**ADVENT**  
**VIDEOBEAM 1000A**  
**SERVICE MANUAL CORRECTION SHEETS**  
**(\*\*FOR REPRINTED MANUAL OF 3/17/77)**  
**(\*FOR REPRINTED MANUAL OF 1/1/78)**  
**(No Asterisk – Correction No. 1 After 1/1/78)**

Please make the following changes to your service manual:

5-1

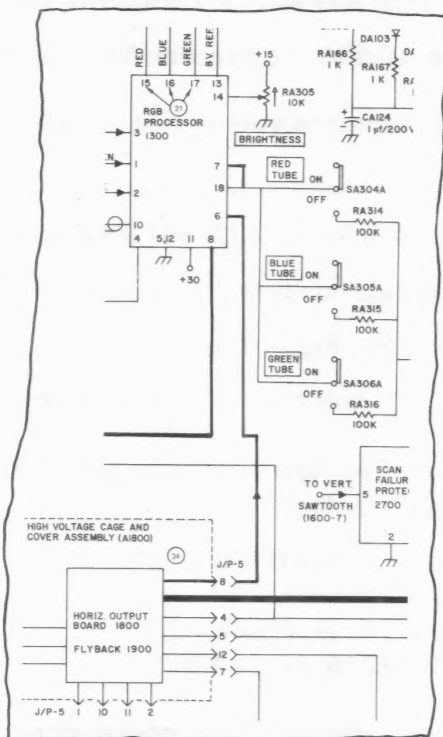
\*\* Change schematic area on 5-1 and pocket schematic as follows:

Add a line from Board 1300 Pin 18 to Board 1300 Pin 7.  
 Add a line from Board 1700 Pin 11 to Board 1300 Pin 8.  
 Add a line from Junction/Plug 5 pin 8 to Board 1300 Pin 6.  
 Delete a line from Junction/Plug 5 pin 8 to Center Tap of SA306A.

5-1

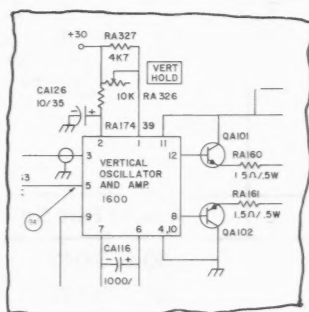
\*\* Change schematic area on 5-1 and pocket schematic as follows:

Add CA126 10  $\mu$ f/35V electrolytic with the following connections:  
 Positive side (+) connected to Board 1600 Pin 2  
 Negative side (-) connected to chassis ground.

Add RA174 39 $\Omega$  1/4W 10% with the following connections:  
 One end connected to Board 1600 Pin 2  
 Other end connected to the 30V supply placing RA174 in series with the 30V supply.

5-4

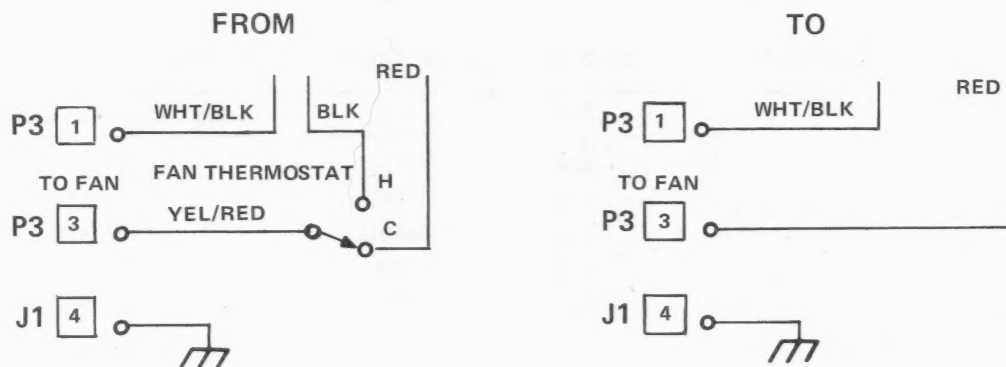
Delete the following component and note date effective:

Fan Thermostat; effective 2 months after start of 1000A production.

Change the following lines on the schematic drawing as shown:

5-4  
and  
5-4A

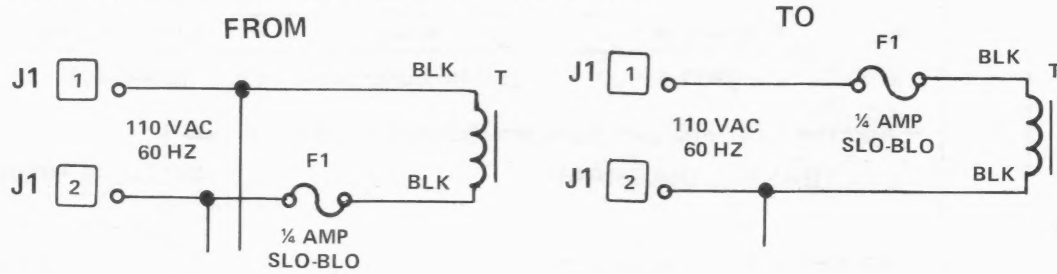
Change the position of the following component on schematic as shown and note date effective.

Fuse, F1, ¼AMP.-slow blow. Date effective 2/27/78.

5-6

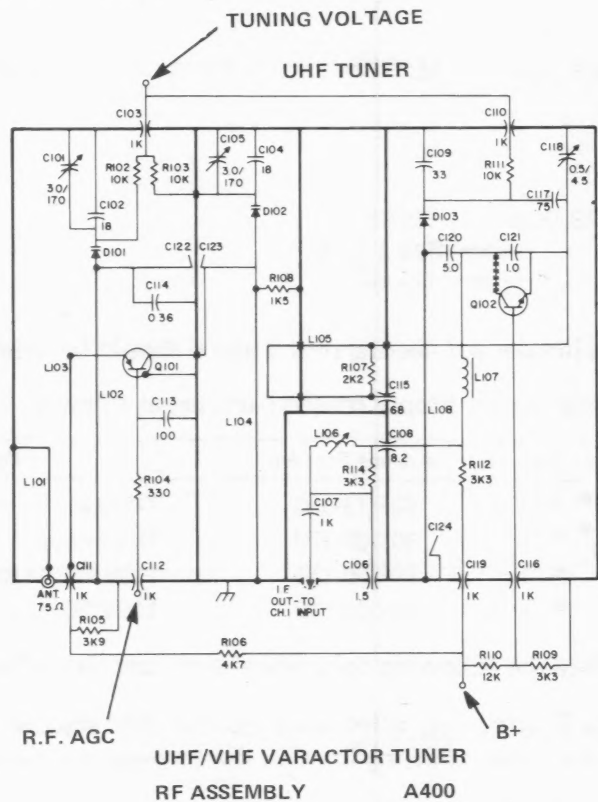
Add the notes shown by arrows:

5-19

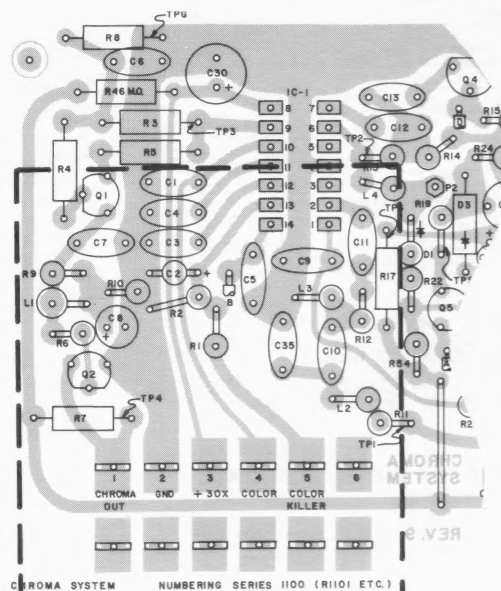
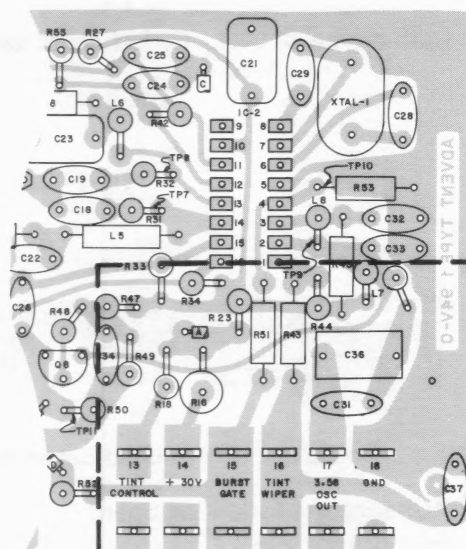
**\*\*New board assembly areas as shown:**

Changes in area "A" are as follows:  
10K deleted. C5 and C9 relocated to component side of board.

Changes in area "B" are as follows:  
C35 relabeled C37. C31 changes value. C36 is added.

5-20 \*\* Change schematic area as shown:

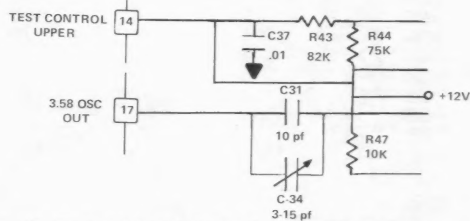
IC2:

5-20 \*\* C-35 relabeled C37. C31 changes value, C36 is added.

5-32

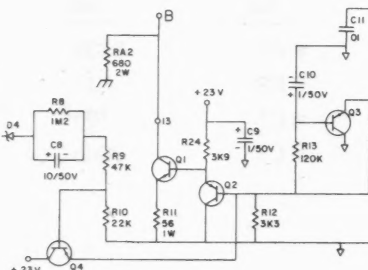
\*\* Change the following components as follows:

\*\* Delete diode D5

\*\* Add Transistor Q4 as shown

\* R21 from 82K to 75K Effective 11/12/75

\* C4 from 0.39 to 0.33 Effective 3/17/76

### UHF Reception Problems

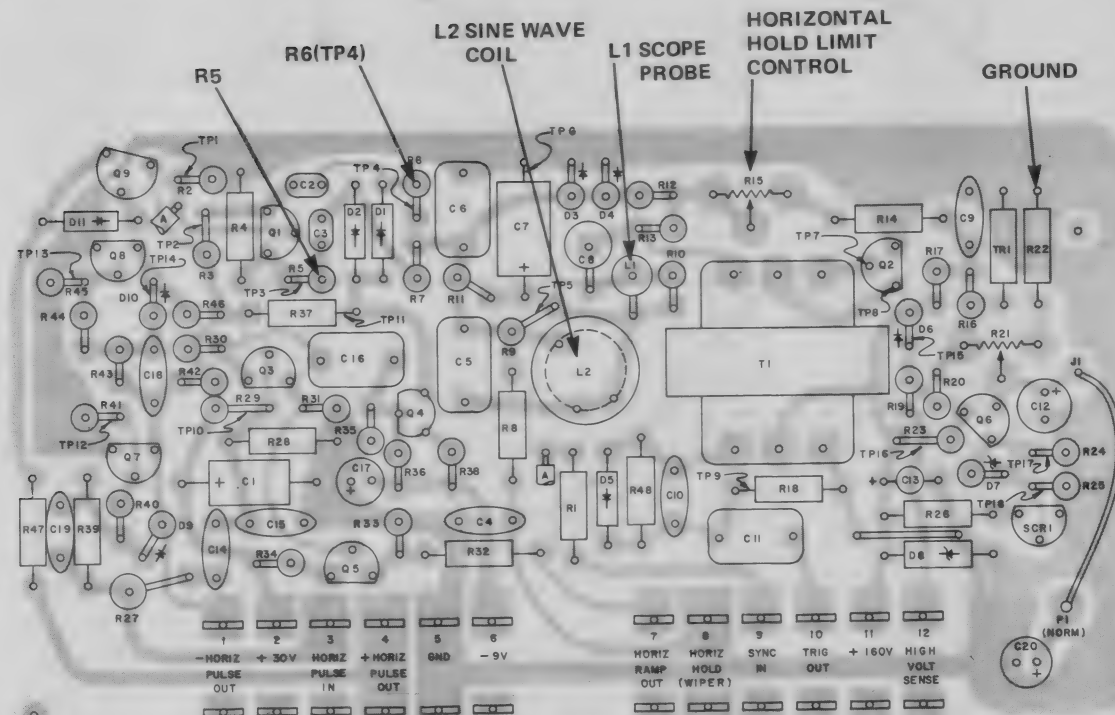
If you experience poor UHF reception with proper signal level change zener diode D5 on the AGC/IF Processor Board to an 8.2 V Zener Advent Pt. No. 60-663-017 (1N5237A).

HORIZONTAL OSCILLATOR NUMBERING SERIES 1700 (R1701 ETC.)

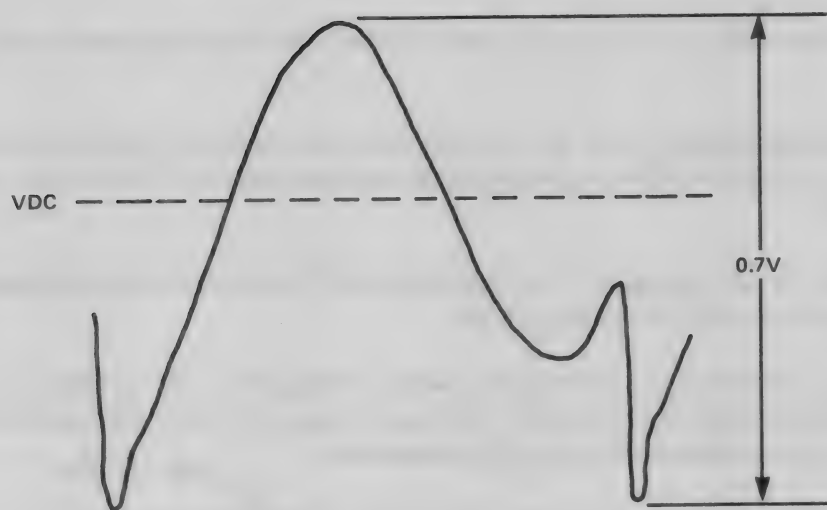
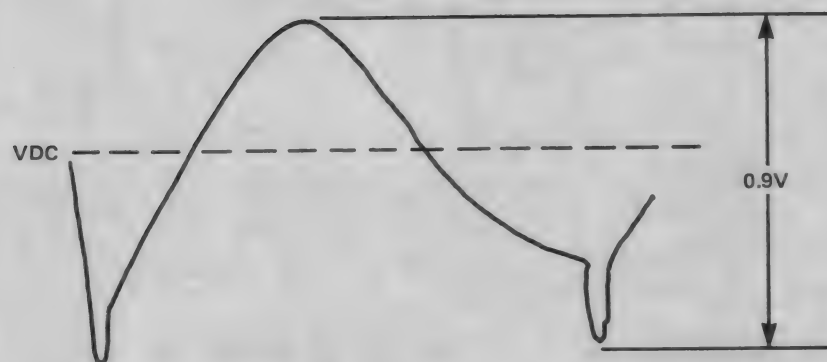
1. Step #1 is not absolutely necessary, but will give the horizontal hold top panel control symmetry in frequency range. If resistor (R5) on the horizontal oscillator board #1700 is 2.7K, replace it with a 1K8 ¼W 10%.
2. Attach a scope probe to the top end of L1 and ground to R22 as shown below. Set scope sweep to 10u sec. per cm. and 0.1V/cm sensitivity.
3. Adjust L2 (sine wave coil) shown on the diagram below for waveform "A" as shown on page 3 with proper amplitude. Keep the horizontal oscillator in sync. by use of the horizontal hold limit control shown below while performing this adjustment.
4. Attach the scope probe to the top end of R6 (TP4) shown. Adjust waveform "B," as shown to 0 VDC  $\pm$  0.1 V by DC coupling the scope input.

Waveform "C" is shown as the most unstable and incorrect waveform. To go from waveform "C" to waveform "A" you would have to rotate the L2 slug in a clockwise direction.
